Agenda Item: **201303719 6545, 6555, 6555 (rear) Roswell Road** a request to rezone the subject property from C-1(Community Business District) to C-1(Community Business District) to allow restaurant and commercial uses, with concurrent variances.

Rezoning Petition No. 201303719

Prepared by the City of Sandy Springs Department of Community Development for the Mayor and City Council February 18, 2014

PROJECT NAME:	ZAXBY'S
SHEET TITLE:	SITE PLAN
SHEET NUMBER:	1
PROJECT NUMBER:	12726ZAX
DATE:	10/30/13

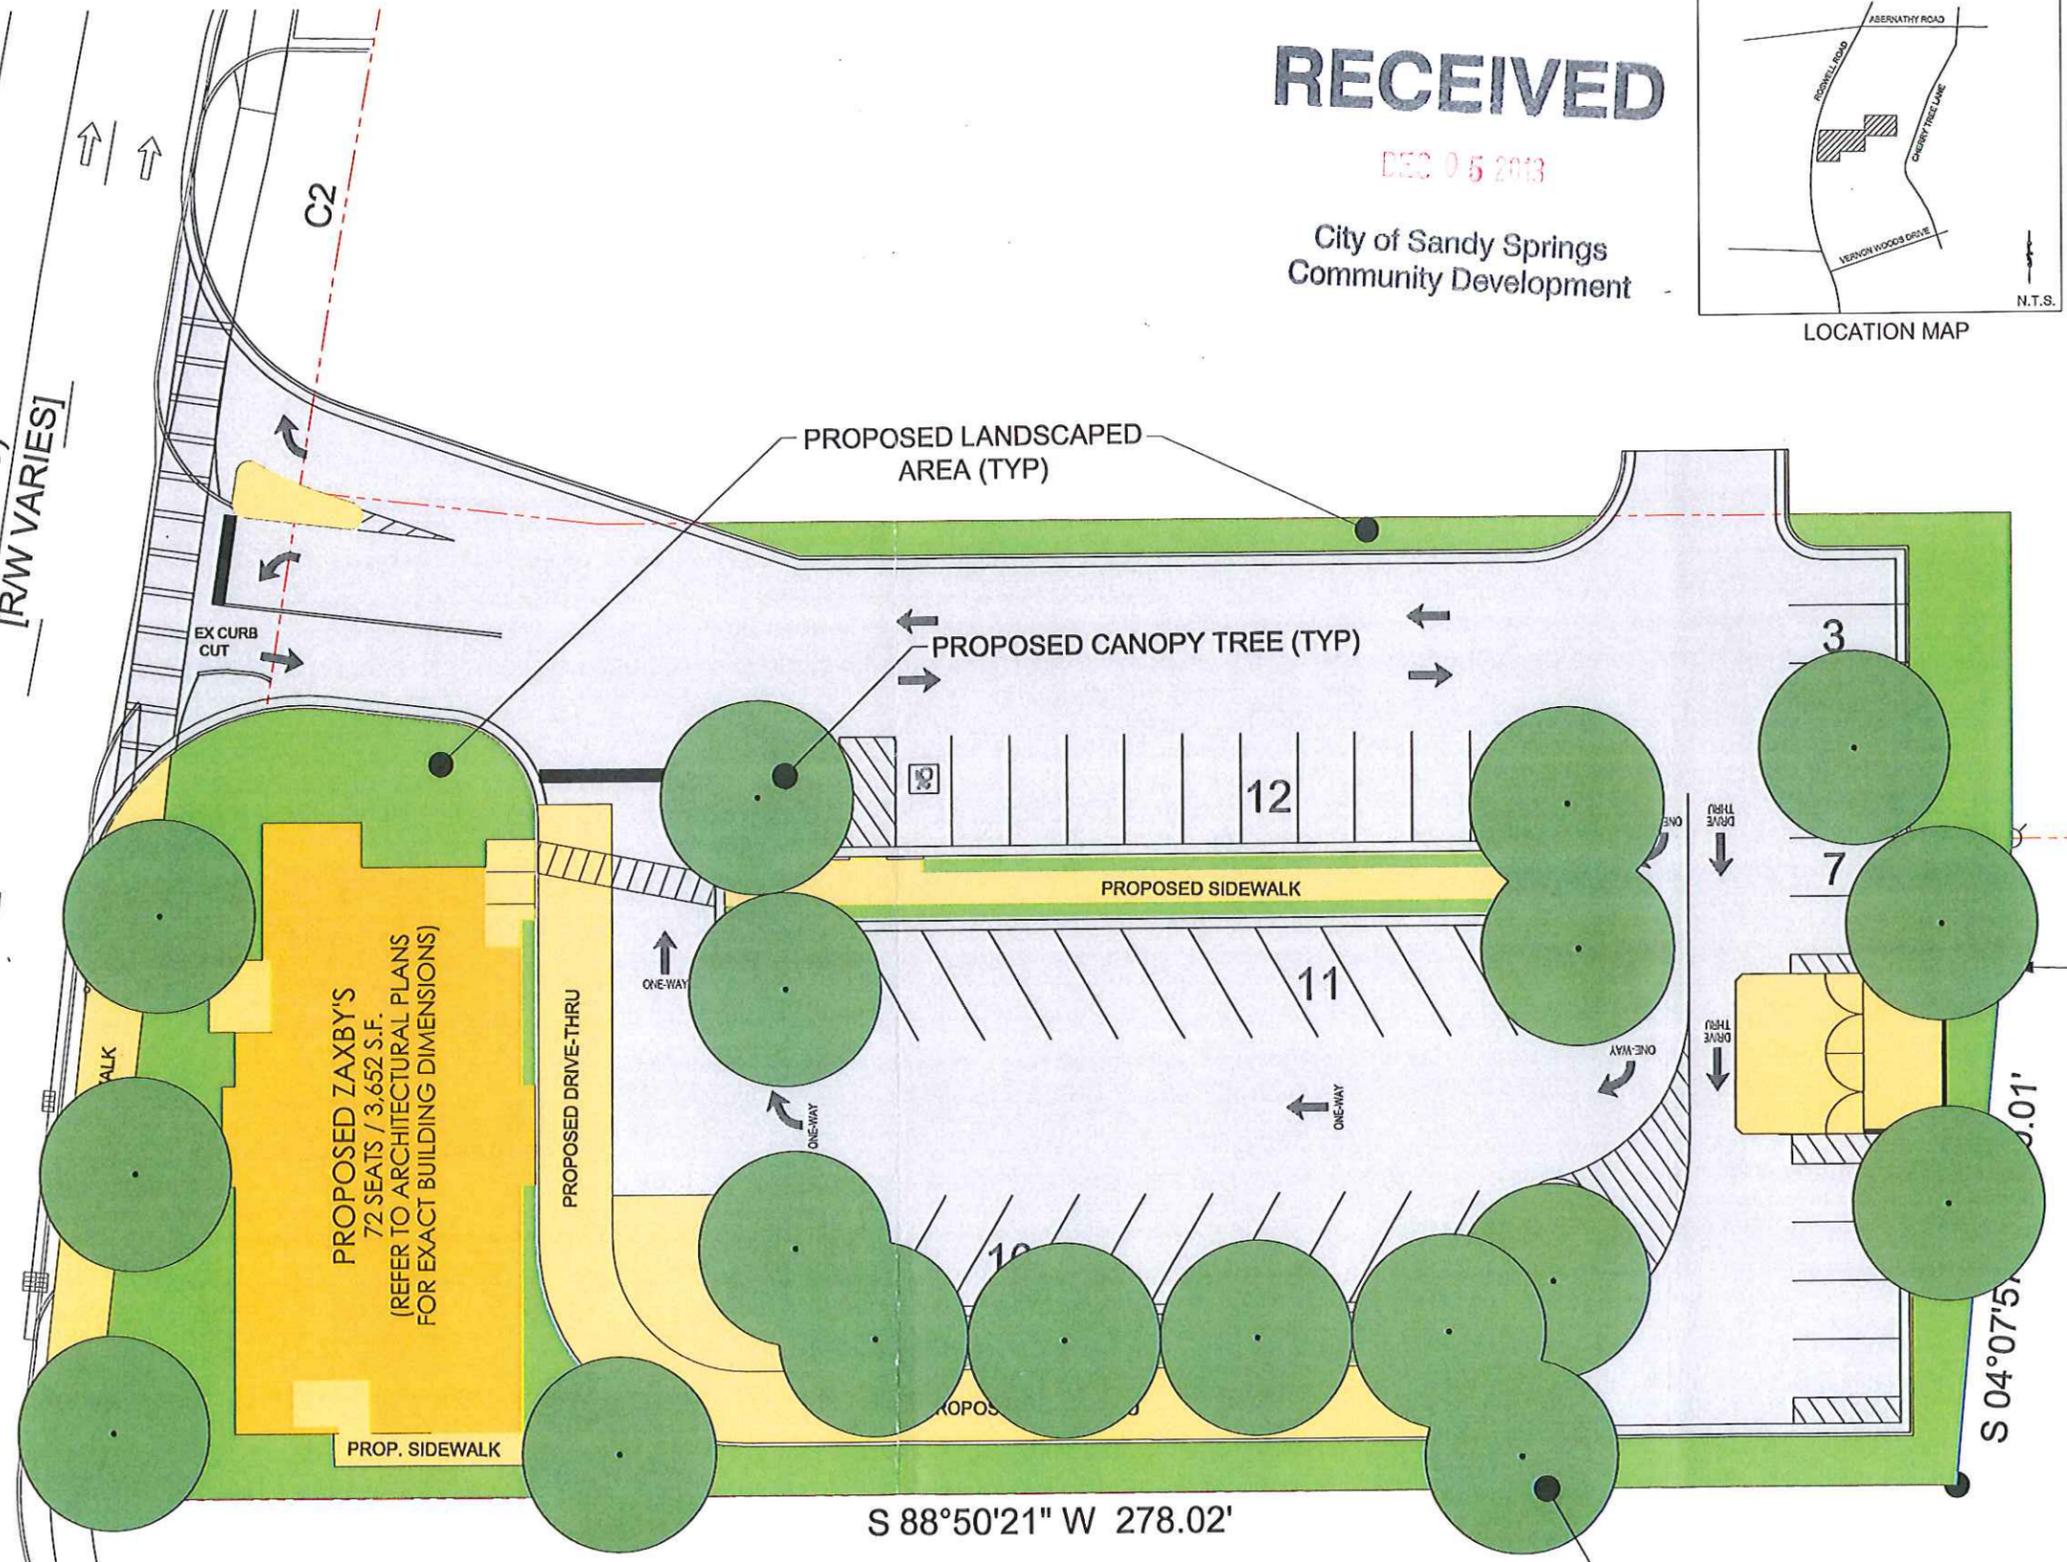
1. Variance from Section 4.23.1 to reduce the fifty (50) foot rear buffer to ten (10) feet along rear property line and to zero (0) for the access to the rear portion of the property.

Staff is of the opinion that the reduction of the buffer is in harmony with the intent of the zoning ordinance. The rear property line is adjacent to R-3 (Single Family Dwelling District) which contains a high intensity transmission line easement. The easement creates a buffer between the single family residential homes of approximately 100 feet. Additionally, the applicant is requesting to reduce the buffer to zero (0) along the 69x10 foot access point to the north east portion of the property. Therefore, based on these reasons, the staff recommends APPROVAL of this variance request.

2. Variance from Section 12.B.8.A.3 to increase the maximum number of parking spaces permitted from 37 to 43 spaces.

Staff is of the opinion that the increase in the maximum number of parking spaces is in harmony with the intent of the Zoning Ordinance and would not cause a detriment to the public. The applicant has indicated that their restaurant would require more spaces than allowed by the ordinance. The applicant will be required to install parking lot landscaping per the current regulations. Not allowing additional parking spaces could lead to overflow parking on other properties. Therefore, based on these reasons, the staff recommends APPROVAL of this variance request.

4. Variance from Section 103-72 of the Sandy Springs Development Regulations to delete the requirement for interparcel access along the south.

Staff is of the opinion that the request to delete the requirement for interparcel access along the south property line is in harmony with the intent of the Zoning Ordinance and would not cause a detriment to the public. Additionally, a hardship is created due to the topography along the south property line which makes it impractical to install interparcel access. Therefore, based on these reasons, the staff recommends APPROVAL of this variance request.

5. Variance from Section 33.22.C to reduce the ten (10) foot setback to zero (0).

There is approximately a seven (7) foot elevation difference between Roswell Road and the location of the proposed restaurant. Also, the Main Street Overlay District requires the building be pushed closer to Roswell Road which would create an obstruction of the sign from the south if it is required to be setback ten (10) feet. Therefore, based on this reason the staff is of the opinion this standard has been satisfied.

1. To the owner's agreement to provide the following site development standards:
 - a. Variance from Section 4.23.1 to reduce the fifty (50) foot rear buffer to ten (10) feet along rear property line and to zero (0) for the access to the rear portion of the property. (CV-201303719 #1)

- b. Variance from Section 12. B.8.A.3 to the maximum number of parking space permitted from 37 to 43 spaces. (CV-201303719 #2)
 - c. Variance from Section 12.B.8.E.2 to decrease the minimum height from 25 feet to 18 feet. (CV-201303719 #3)

- d. Variance from Section 103-72 of the Sandy Springs Development Regulations to delete the requirement for interparcel access to the property to the south. (CV-201303719 #4)

- e. Variance from Section 33.22.C to reduce the 10 foot setback to 0 feet. (CV-201303719 #5)
 - f. Variance from Section Section12B.8.F.2.c to reduce the 60% transparent glazing on the ground floor façade to 18%. (CV-201303719 #7)

FRONT & REAR
LATHING ELEVATIONS

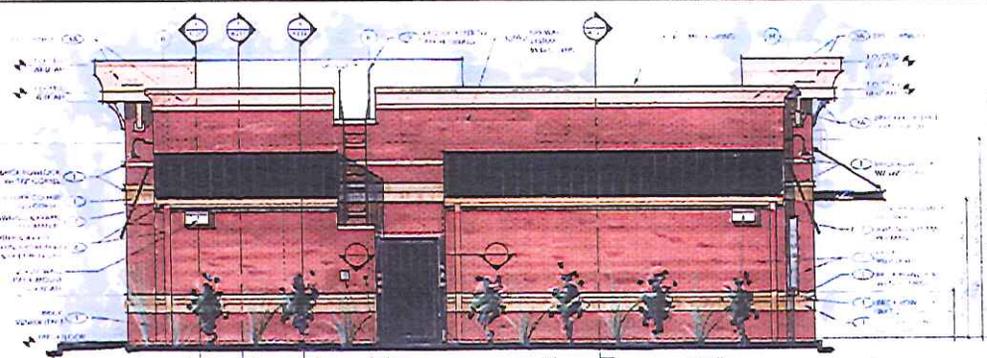
The petition was heard at the January 16, 2014 Planning Commission meeting. The Commission made a recommendation for **approval** (5-1, Tart, Frostbaum, Nickles, Maziar, Porter for; Squire against; Duncan not voting) subject to screen the rear of the building (south elevation) and staff's conditions.

6. Variance from Section 33.22.H to allow an additional wall sign on the north elevation.

The topography of the property does not restrict the location of the proposed sign on the north elevation. The applicant is requesting an additional sign to identify the front entrance of the building. To provide adequate drive thru stacking and meet City regulations the front of the Zaxby's building face the north elevation. The west elevation (Roswell Road) will be the side of the building. The sign ordinance allows wall signs on street facing walls. Therefore, based on this reason the staff is of the opinion this standard has not been satisfied.

7. Variance from Section 12B.8.F.2.c. To reduce the required 60% of ground level façade to 18%.

Staff is of the opinion that the request to reduce the 60% transparent glazing on the ground floor façade to 18% is in harmony with the intent of the Zoning Ordinance and would not cause a detriment to the public. Additionally, it is consistent with other restaurants and buildings in the surrounding area. The proposed building is similar in design to other fast food restaurants, with the storage and kitchen area located in the rear of the building. It is not desirable to have transparent glazing in these locations. Also, due to the building conforming to additional Overlay District requirement the building has been turned to have the main entrance facing the north elevation. The intent of the Ordinances is to address multi story

- g. Southwest elevation of the building shall be screened from street view subject to the approval of the Sandy Springs Arborist.
